SERVICE BULLETIN

AMERICAN HONDA MOTOR CO., INC. MOTORCYCLE SERVICE DEPARTMENT

DRIVE SPROCKET RECALL

MODIFICATION TO PREVENT OIL FILTER CASE DAMAGE

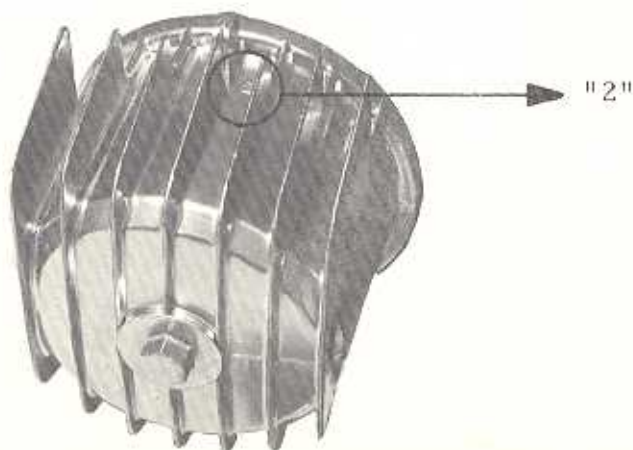
A modified oil filter case and oil filter center bolt have been developed to prevent oil filter case damage.

The width across the flats of the oil filter center bolt has been changed from 14mm to 12mm to prevent over-tightening of the oil filter case. All original center bolts should be replaced with the modified center bolt at the earliest opportunity (periodic inspection, oil change, etc.). The fixing torque for the center bolt is 22-24 lb-ft.

The modified oil filter case is provided with 8 ribs radiating from the center bolt boss inside the case. It is stronger and requires less tightening torque to form an oil seal than the original cases. All oil filter cases should be checked for hairline cracks around the center bolt boss when installing the new center bolt. If any cracks exist, replace the oil filter case with a modified case.

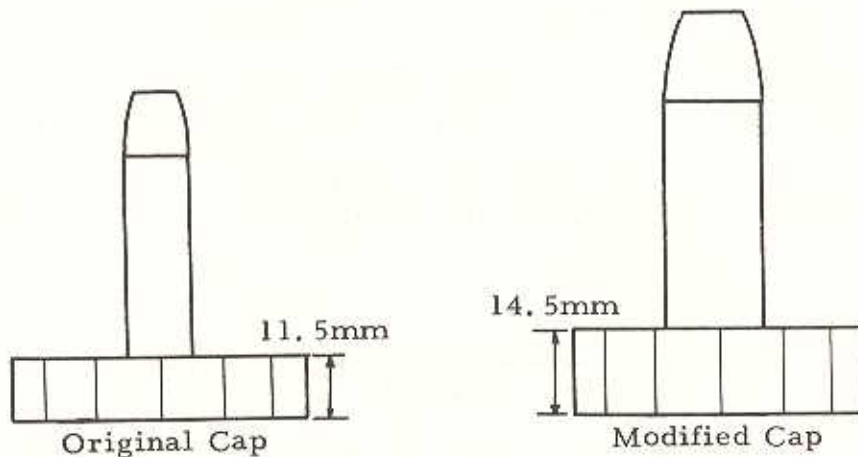
NOTE: Throttle valves must be installed so that cutaway faces rearward and cable slots face inward.

Install right side throttle valves on one long and one short cable end, and install left side throttle valves on the remaining long and short cable ends.

Fig. 1. Camshaft holder and cap showing code stamps.

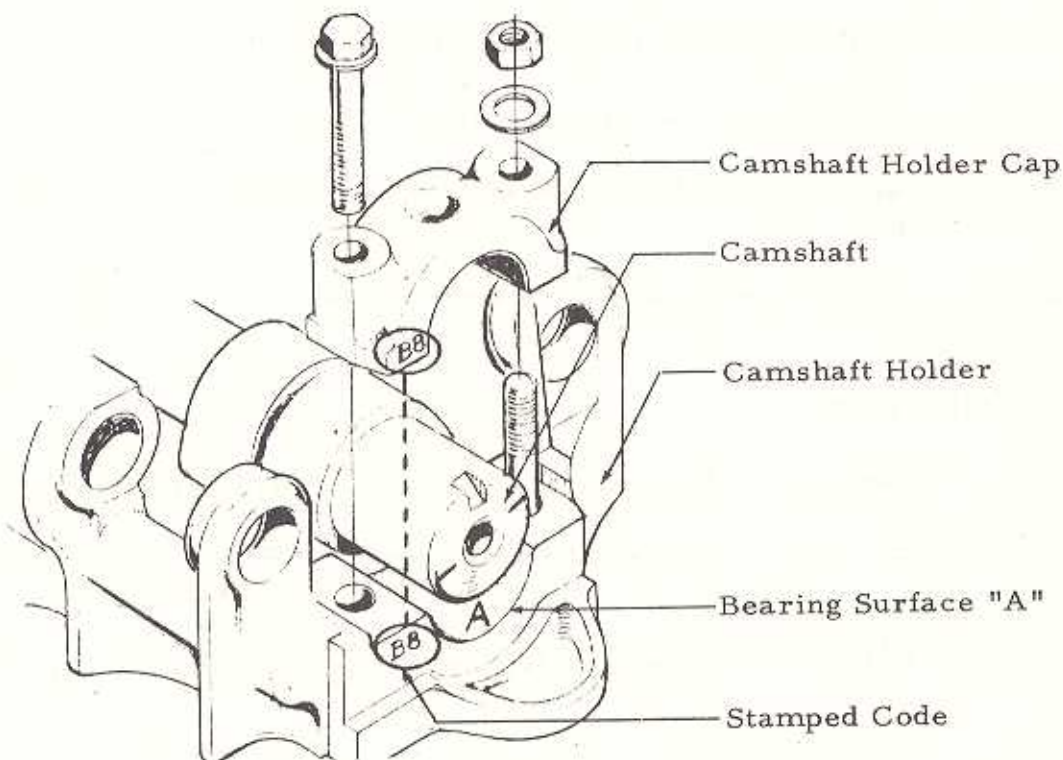
The camshaft holder and holder caps are now available in matched sets only (see Parts Bulletin #750-10). The new camshaft holder has a stamped code on both sides, usually consisting of a letter and a number. An identical code mark is stamped on one side of the camshaft holder cap.

The camshaft holder caps should be mounted on the camshaft holder so that the code stamp on the holder is adjacent to the matching stamp on the holder cap (see Fig. 1, above).

Fig. 1. Modified Chain Cover

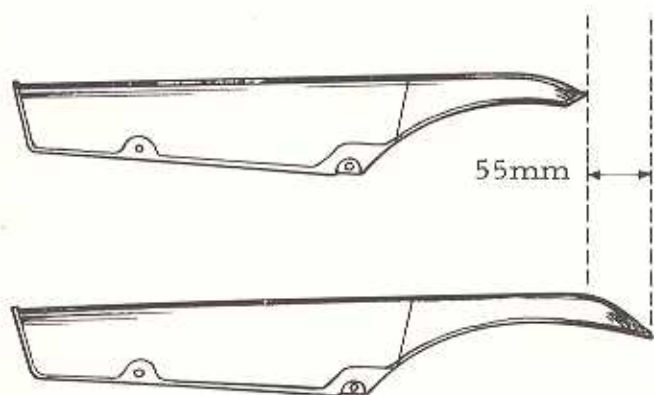
To discourage CB-750 owners from turning off the chain oiler, the chain cover has been modified to prevent surplus chain oil from being thrown onto parts of the machine. The modified chain cover is 55mm longer than the original cover, and tapers to a tip to allow any surplus oil to be carried to the rear, away from the wheel and sprocket. The new chain cover is available at no charge to every owner of a CB-750 within the Frame Number range given below, regardless of normal warranty restrictions on mileage, date of purchase, or ownership.

Fig. 2. Chain Oiler and New Parts

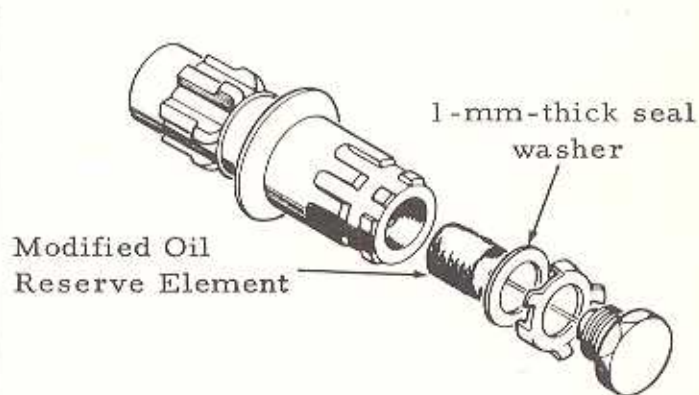
In addition, American Honda is also making available a modified chain oiler reserve element and a 1-mm-thick seal washer to provide better control of the oil flow through the final shaft.

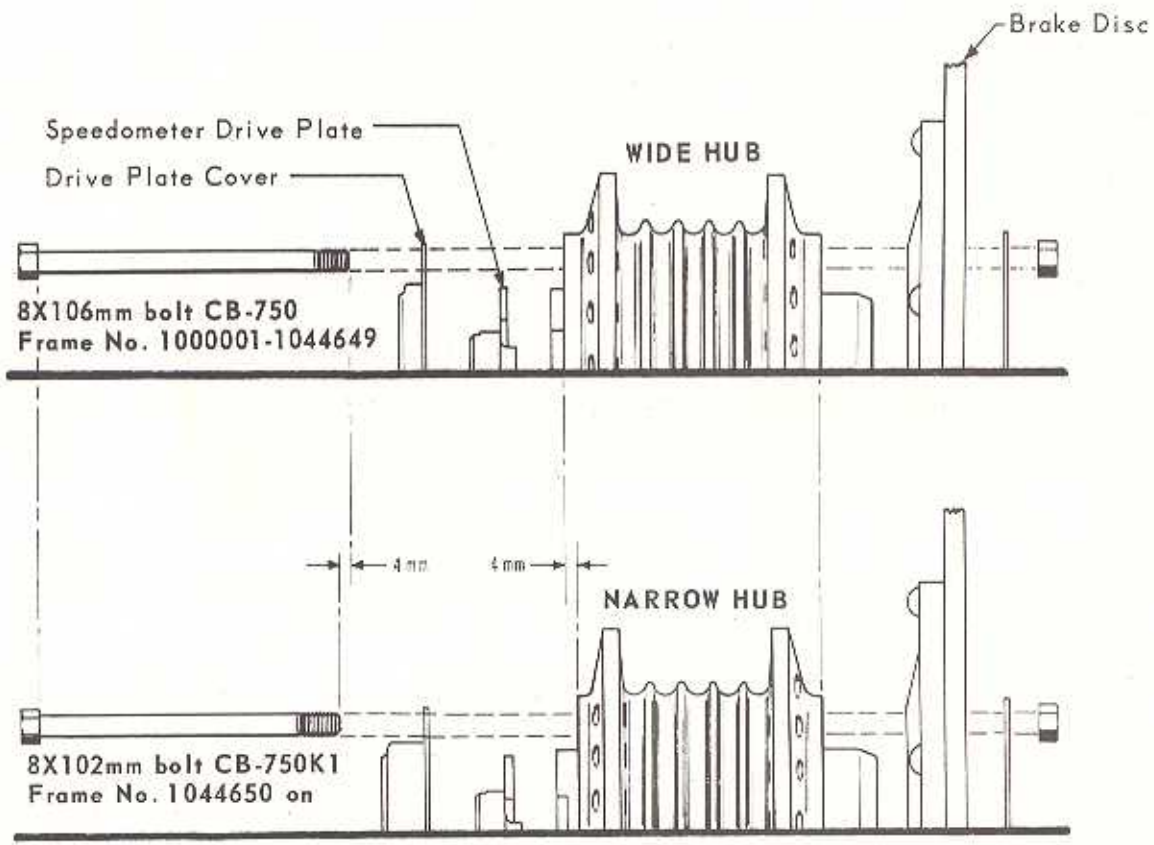
It is especially important to select and install the correct front brake disc mounting bolts. The two types of bolts are visually similar, but if they are inadvertently interchanged, the front brake disc will not be securely mounted.

The shorter (8x102mm) front brake disc mounting bolts (P/N 90122-300-020) must be used with the narrow hub (P/N 44601-300-040).

WARNING: If used with the wide hub, the 8x102mm bolts will be too short to fully engage the retaining nuts.

The longer (8x106mm) front brake disc mounting bolts (P/N 90122-300-010) must be used with the wide hub (P/N 44601-300-030).

Replacement Drive Chain Oiler for Early Engines through #CB750E-1026143:

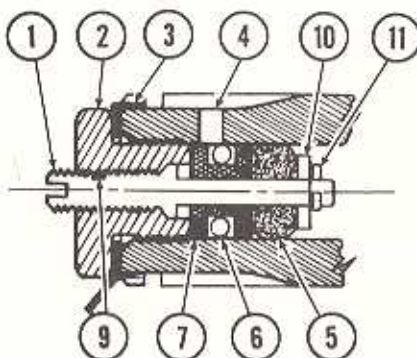
A special replacement drive chain oiler, with adjusting screw, is available for installation on CB-750 engines through number CB750E-1026143.

Drive Chain Oiler for Engines #CB750E-1026144 and subsequent:

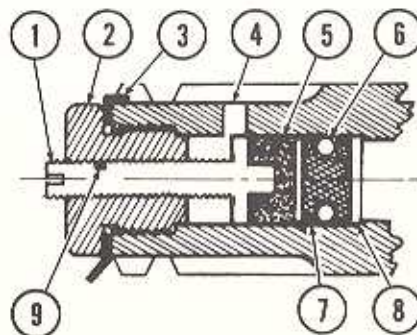
CB750 engines, #CB750-1026144 and subsequent, are factory equipped with a drive chain oiler which has an adjusting screw. This drive chain oiler uses large diameter components which cannot be installed in earlier engines.

H/C 24085
P/N 91255-300-025
OLD OIL SEAL

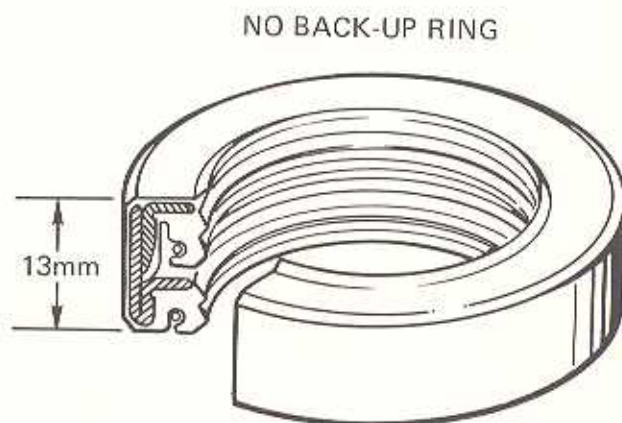
When replacing front fork oil seals in CB-750 K1 and CB-750 K2 motorcycles, install oil seal P/N 91255-341-305. The new oil seal has a double lip.
